51RV-4()/5()

VOR/ILS Navigation Receiver

Component Maintenance Manual

TEMPORARY REVISION NO. 34-35-10-11

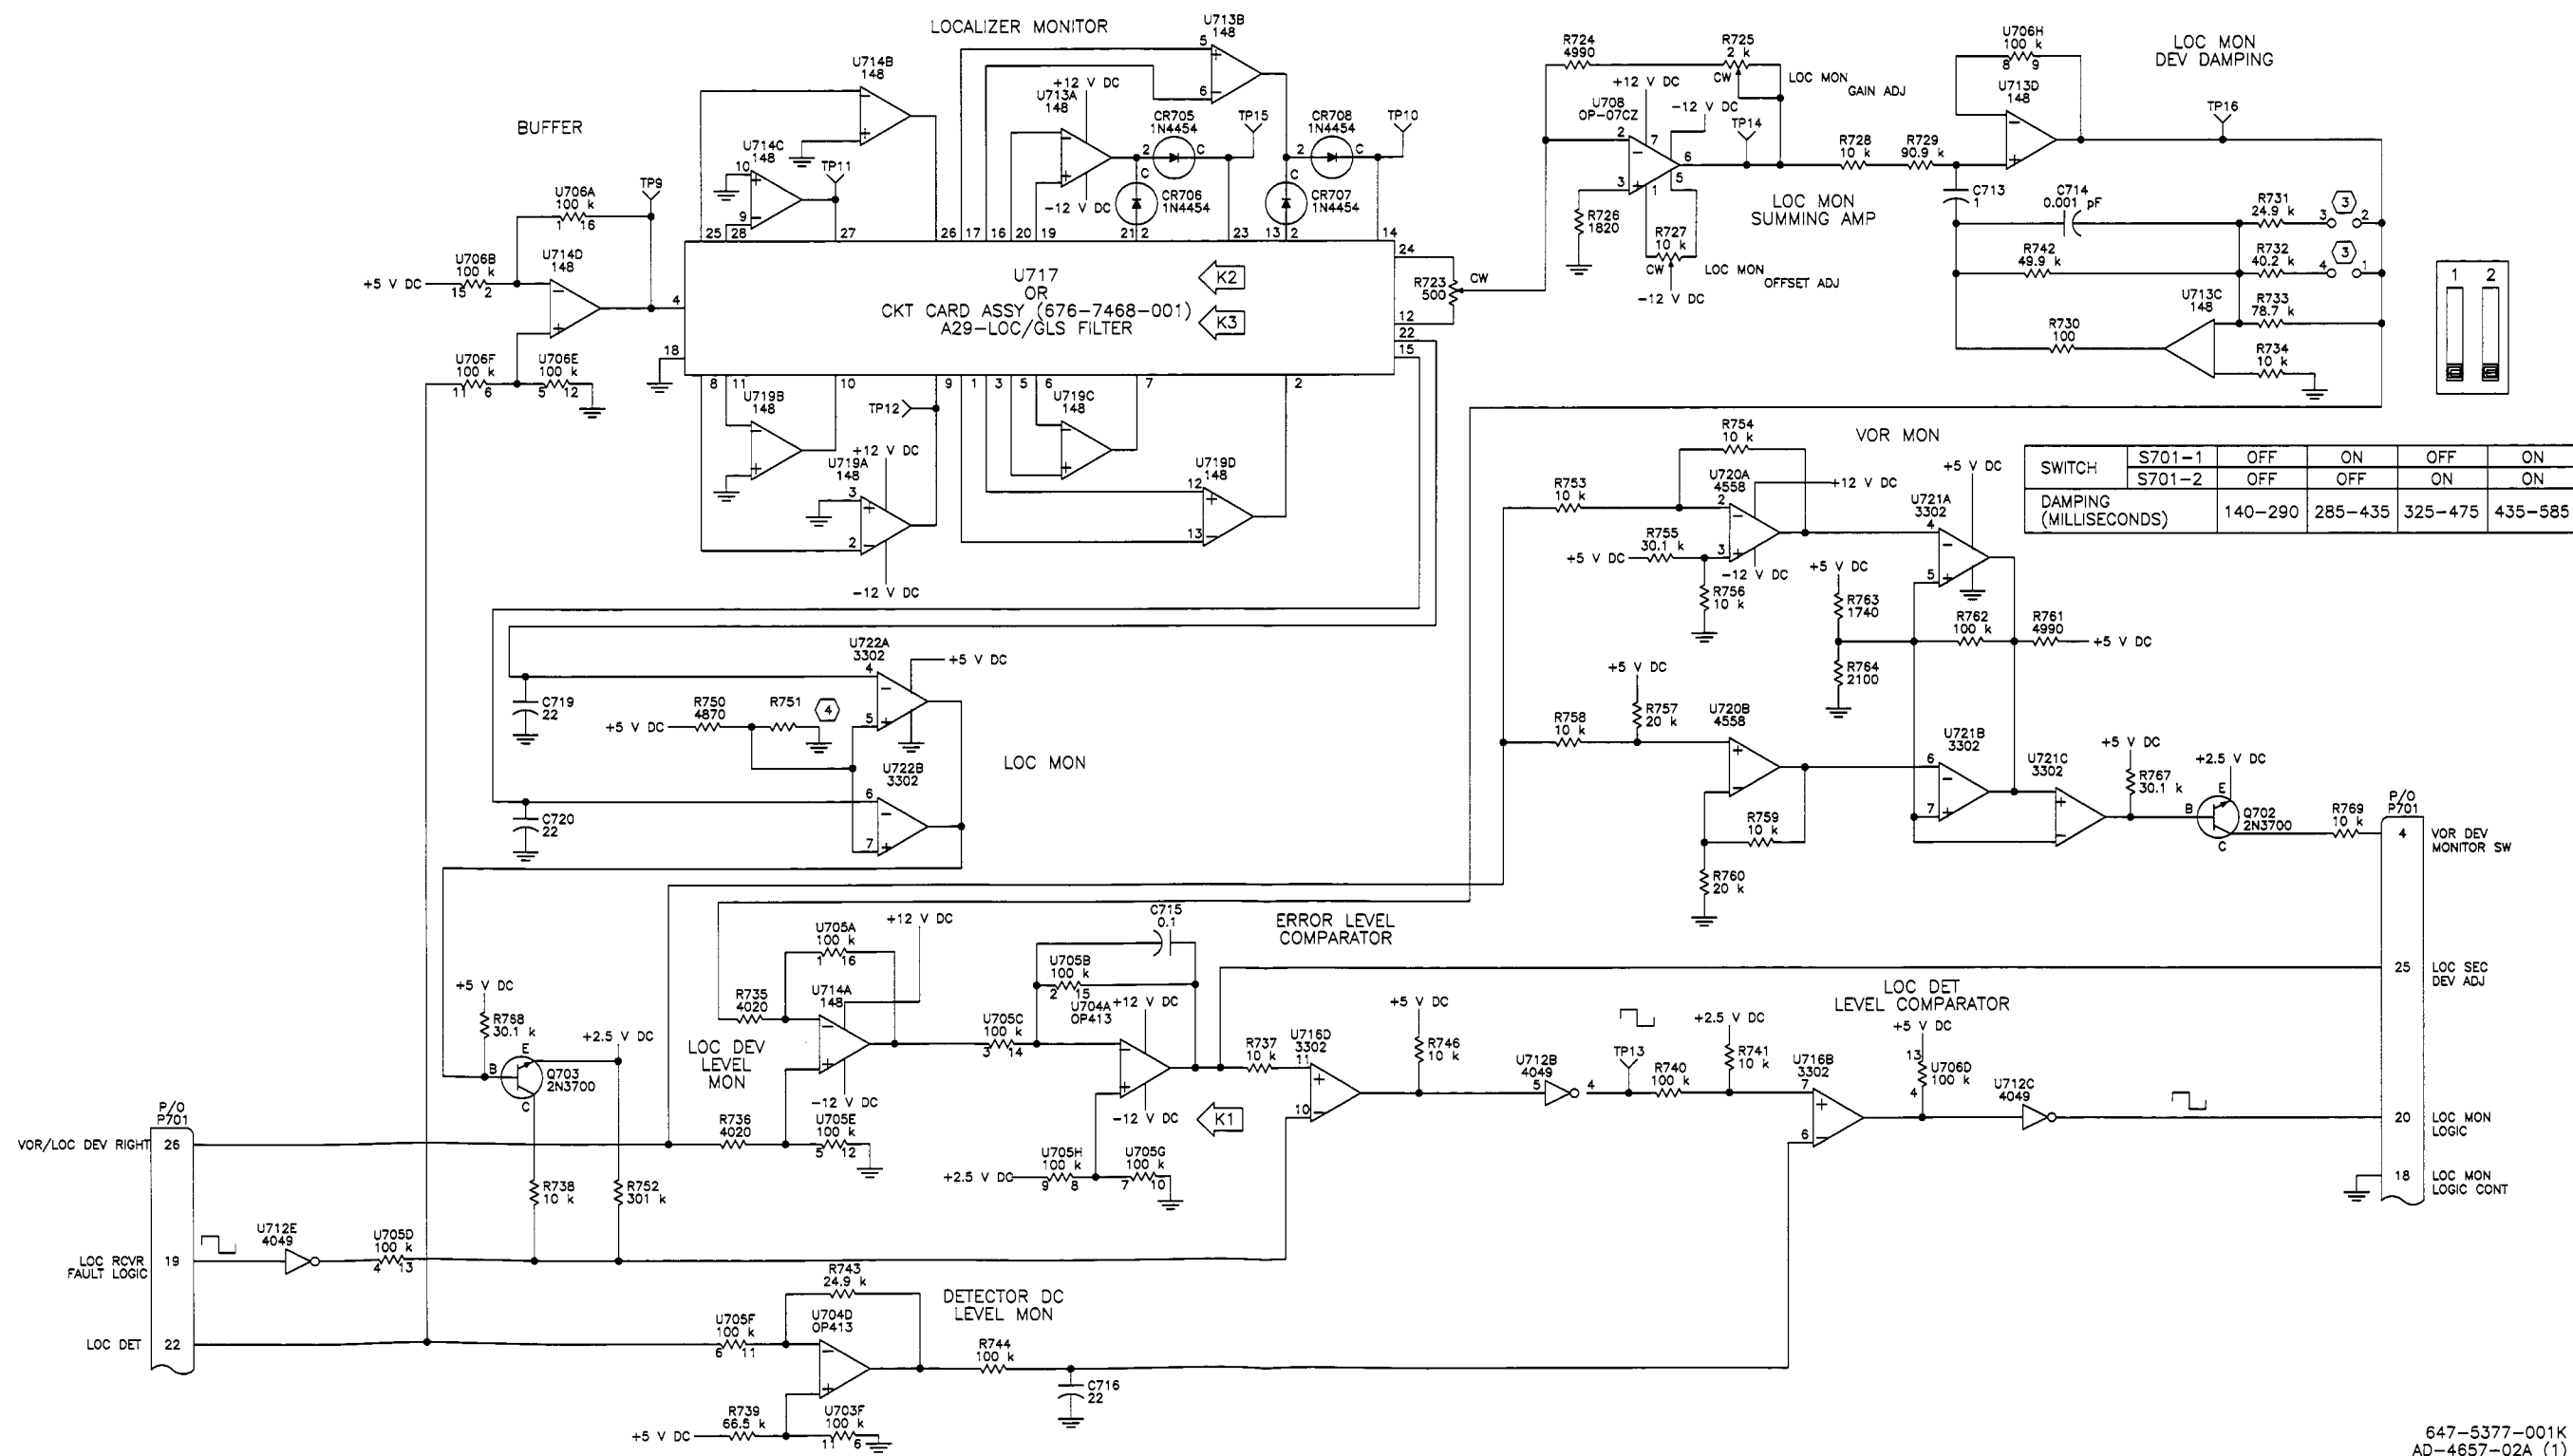
Replace the illustration in Figure 149 (Sheet 1 of 3) with the illustration on the previous page.
